AGENDA
PLANNING COMMISSION
116 WEST NEEDLES
BIXBY, OKLAHOMA
December 16, 2013 **6:00 PM**

To: Bixby Planning Commission
From: Erik Enyart, AICP, City Planner
Date: Wednesday, November 13, 2013
RE: Report and Recommendations for:
Final Plat of "Woodcreek Office Park" – Sack & Associates, Inc. (PUD 47-C)

To: Bixby Planning Commission
From: Erik Enyart, AICP, City Planner
Date: Thursday, November 14, 2013
RE: Report and Recommendations for:
 Preliminary Plat of "Seven Lakes III"

To: Bixby Planning Commission
From: Erik Enyart, AICP, City Planner
Date: Friday, November 15, 2013
RE: Report and Recommendations for:
Preliminary Plat of “Byrnes Mini-Storages” (PUD 77, pending)

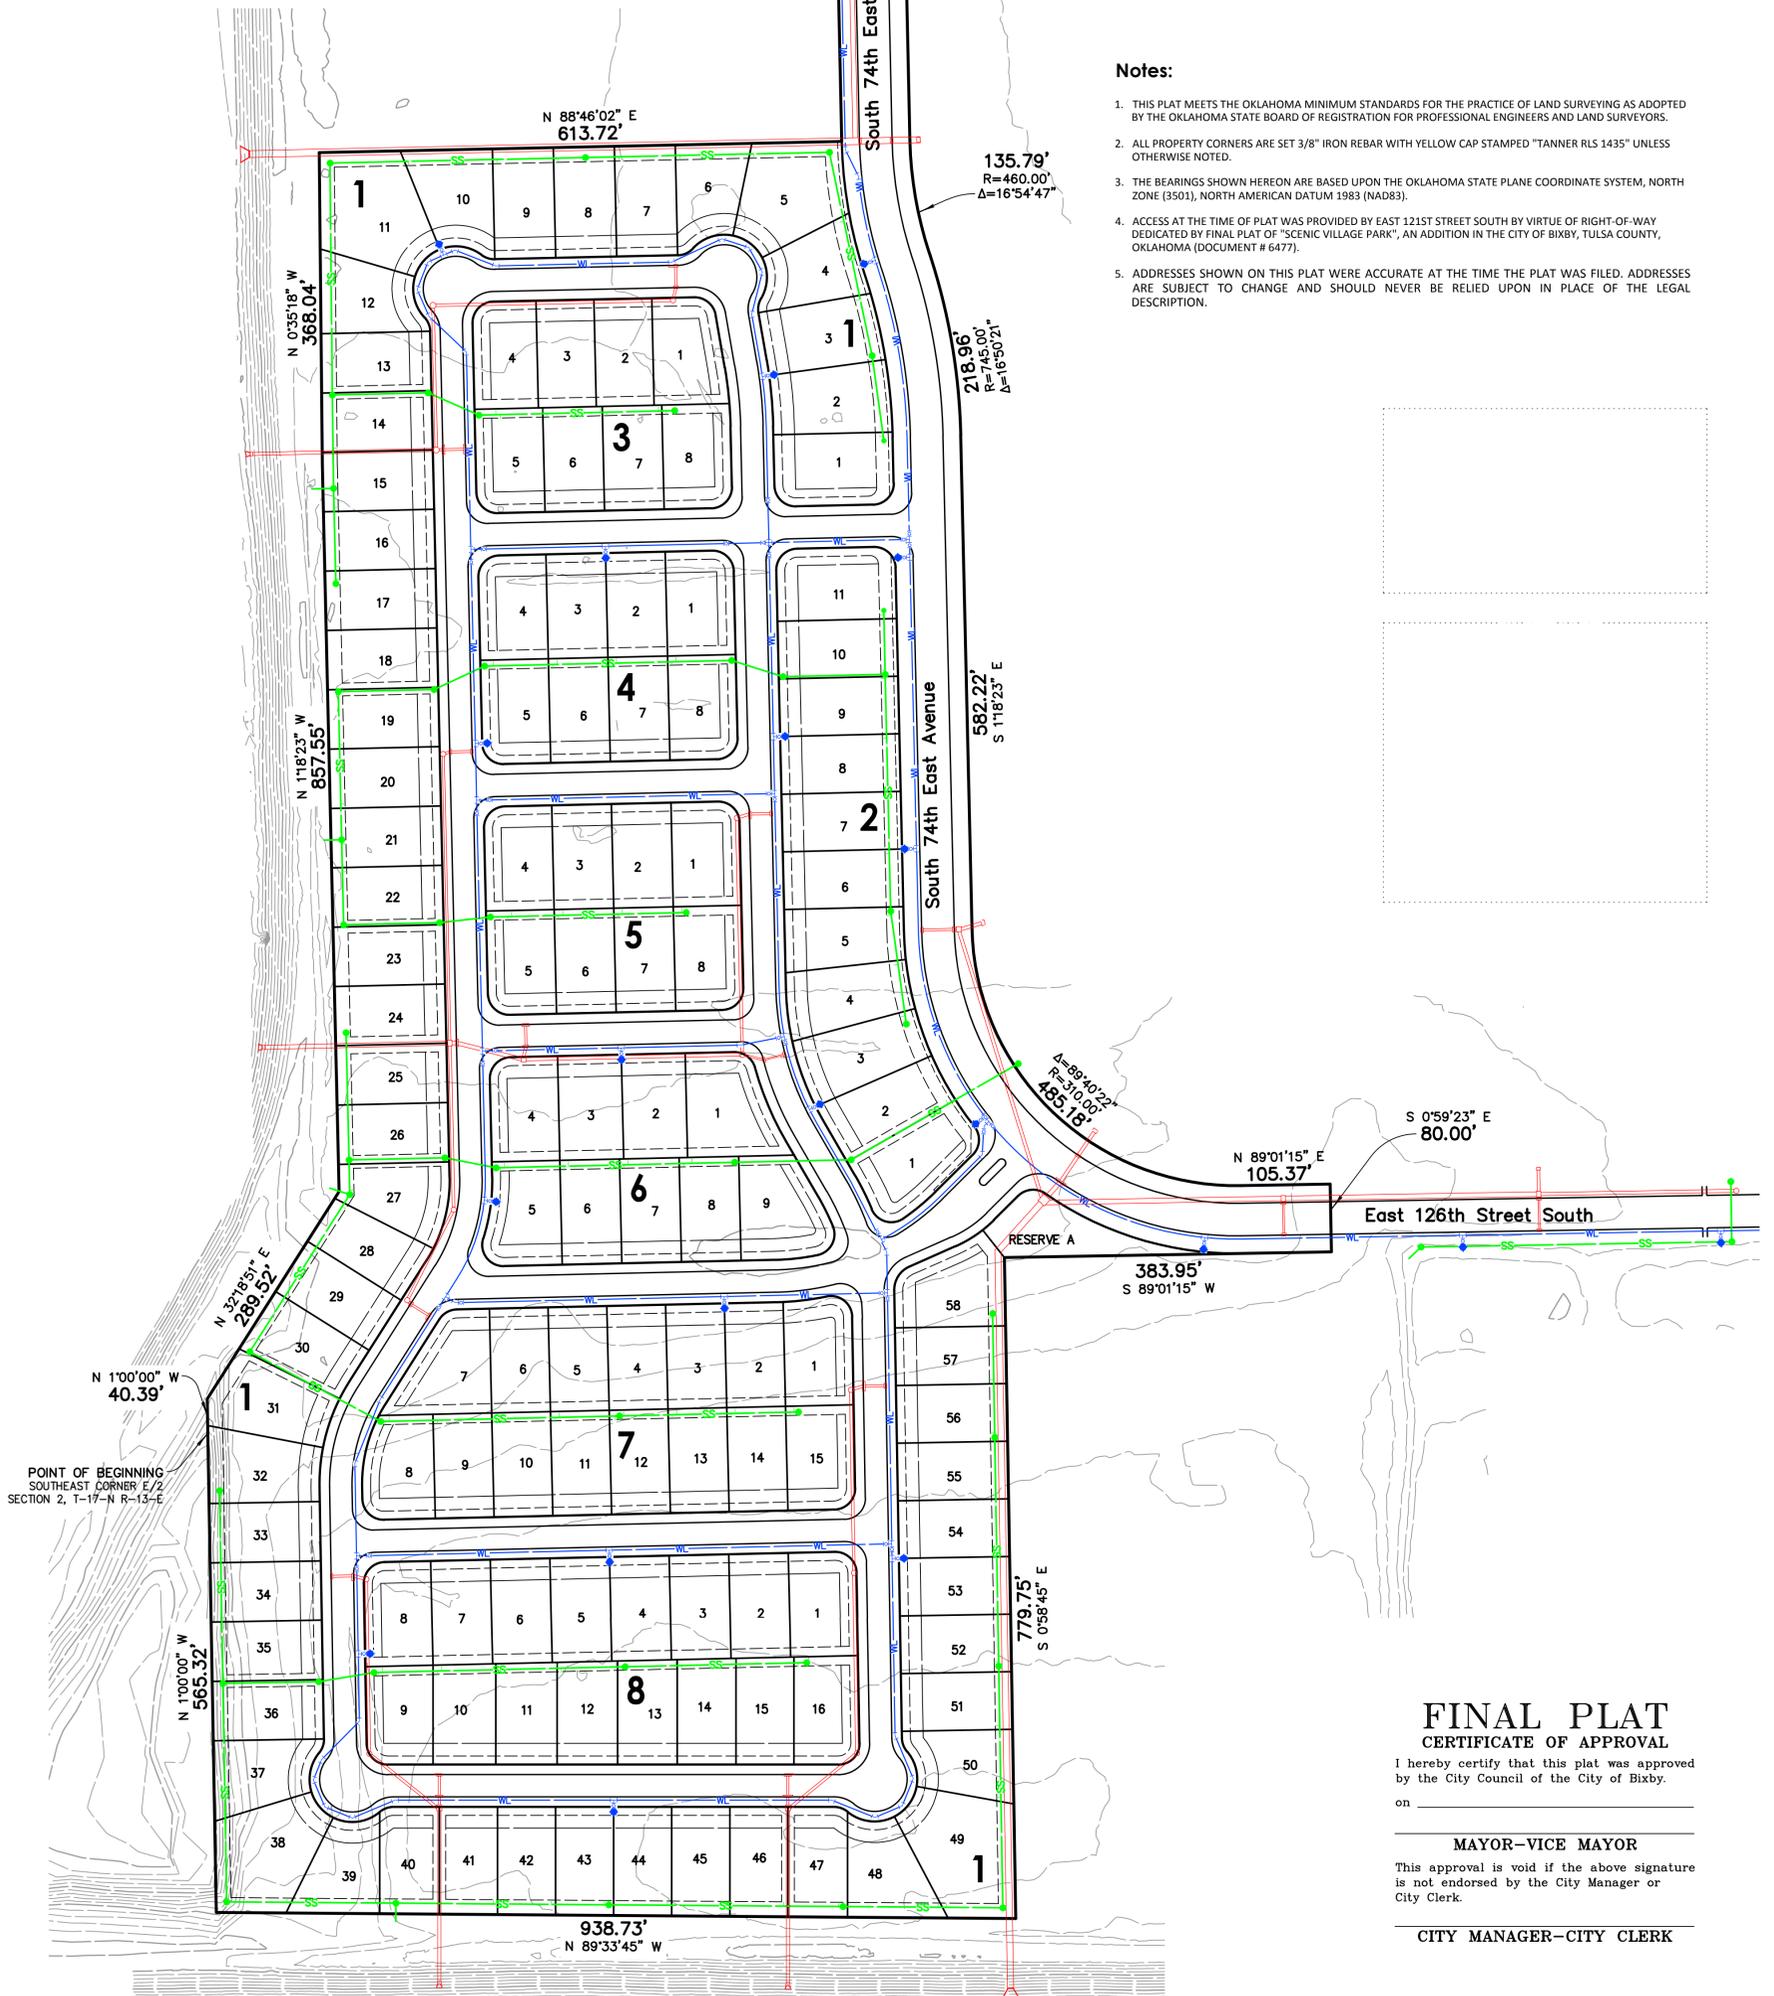
9. Please correct street names as per the street name recommendations drawing dated 12/02/2013, or with appropriate modifications.
 10. Please add proposed addresses to the lots. A table may be used if needed for map clarity.

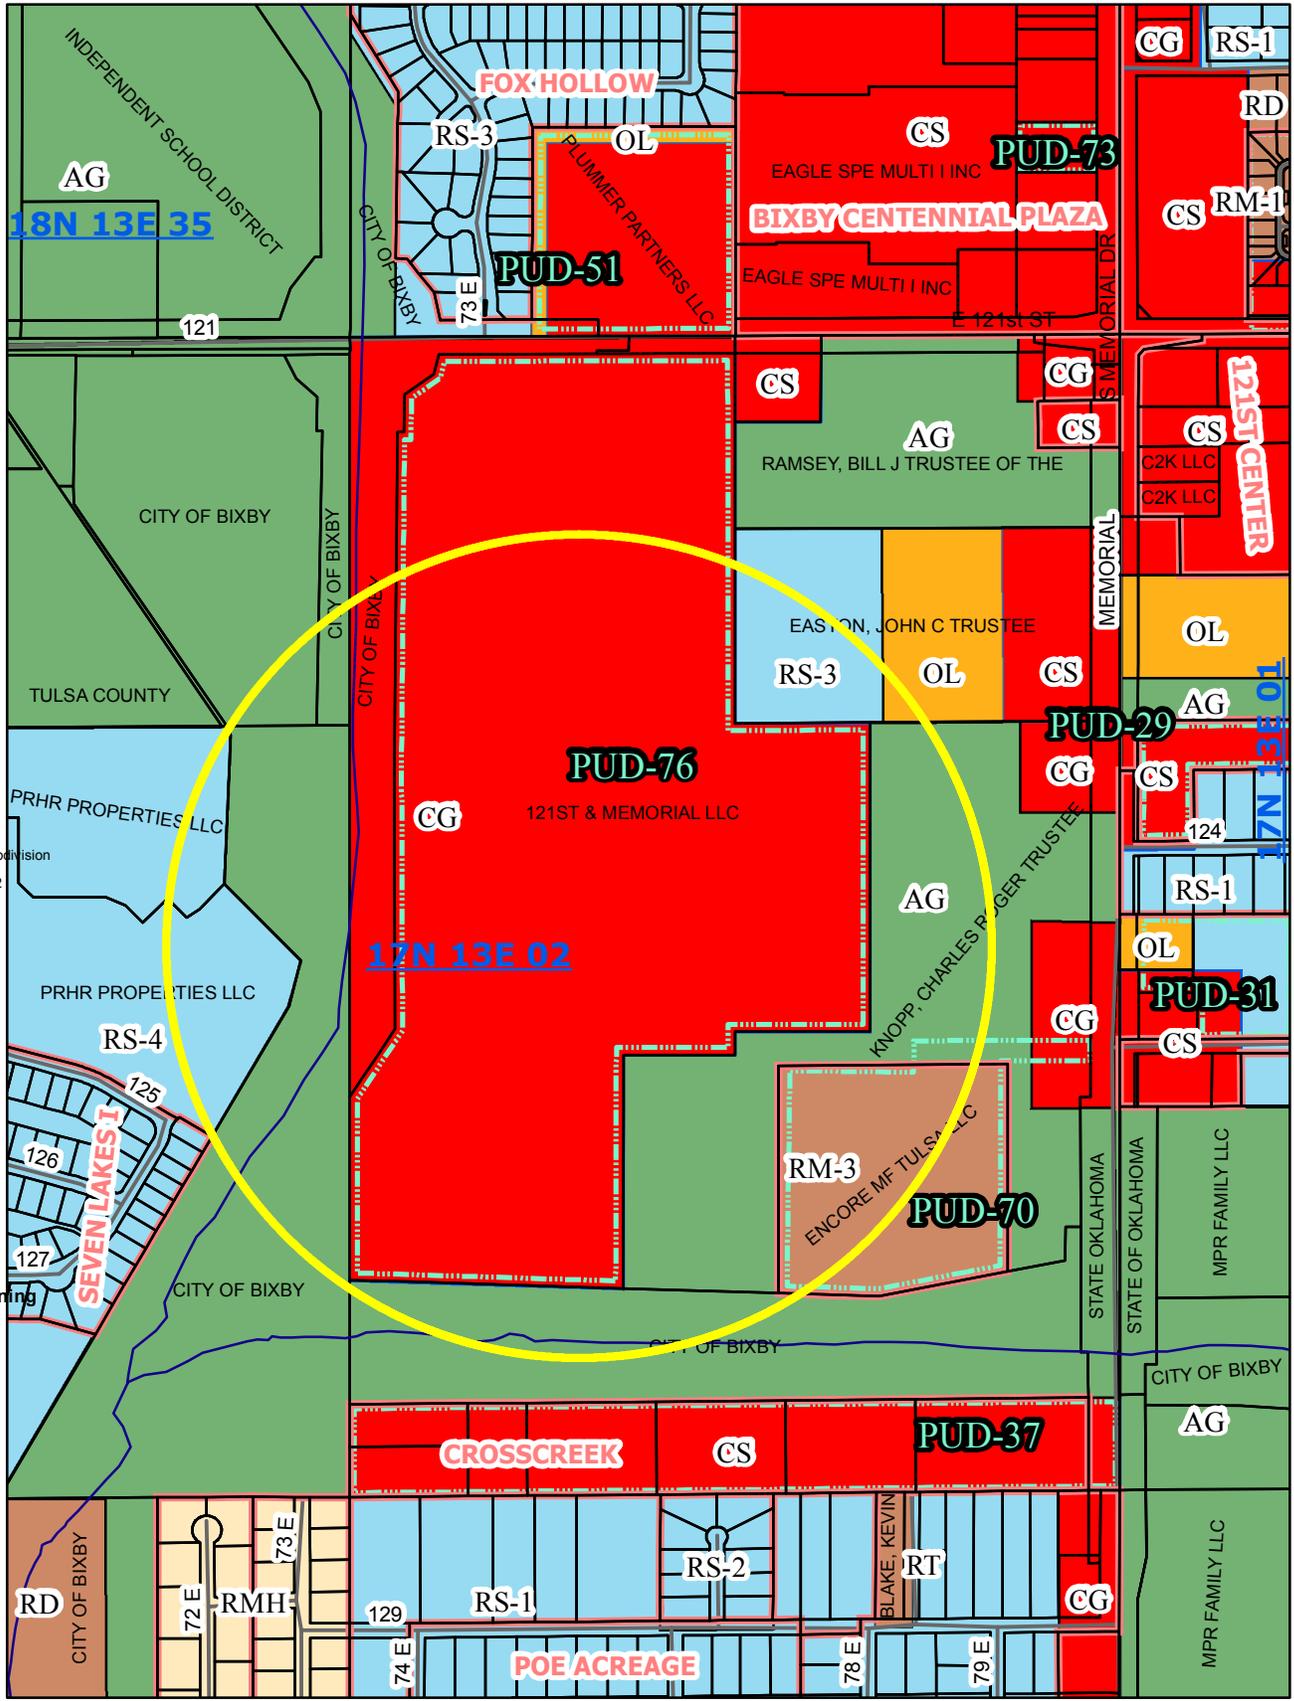
8. Per SRs Section 12-4-2.A.5, a Location Map is required and must include all platted additions within the Section; the following need to be corrected as follows:

- a. *LaCasa Movil Estates 2nd* (mis-labeled)

- b. *Poe Acreage* (misrepresented as to configuration)
 - c. *Seven Lakes II* (misrepresented as to configuration)
 - d. The Fry Creek Ditch # 1 and # 2 are represented but do not reflect channel reconstructions from circa 2000.
